Access Compliance Report Public Rights-of-Way (Curb Ramps)

Main Street: ANTONIO_PKWY		Cross Street: ANTONIO_PKWY		Location:	NW
ADA ID: RPRK211116115848	Ramp Type:Type 1 - Perpendicular	Initial Pass/Fail: Pass	Overall Compliance: No	Severity Score:	17

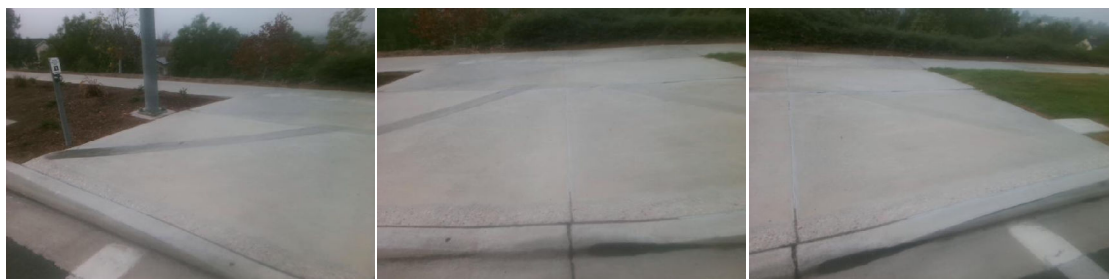
R304.2.2, R304.5.3, R305, R304.5.4, STD 1115

Yes	Ramp Inside Crosswalk 1	Yes	Yes	Ramp Inside Crosswalk 2	N/A
	Crossing 1 Slope (%)	2.1		Crossing 2 Slope (%)	N/A
	Crossing 1 Cross Slope (%)	0.5		Crossing 2 Cross Slope (%)	N/A
Yes	Gutter Ponding	No	No	Curb Slope	7
Yes	Gutter Lip Height (in)	0		Road Run Slope (%)	N/A
No	Gutter Run Slope (%)	8.9		Road Cross Slope (%)	N/A
Yes	Gutter Cross Slope (%)	1.4			
Yes	Overall Surface Condition: Acceptable		Yes	Perp Joint Present	Yes
	Cross Gutter Present?	No		Spandrel Present?	No
	Replace Cross Gutter?	N/A		Replace Spandrel?	N/A

Remove & Replace Entire Ramp. Remove & Replace Gutter.
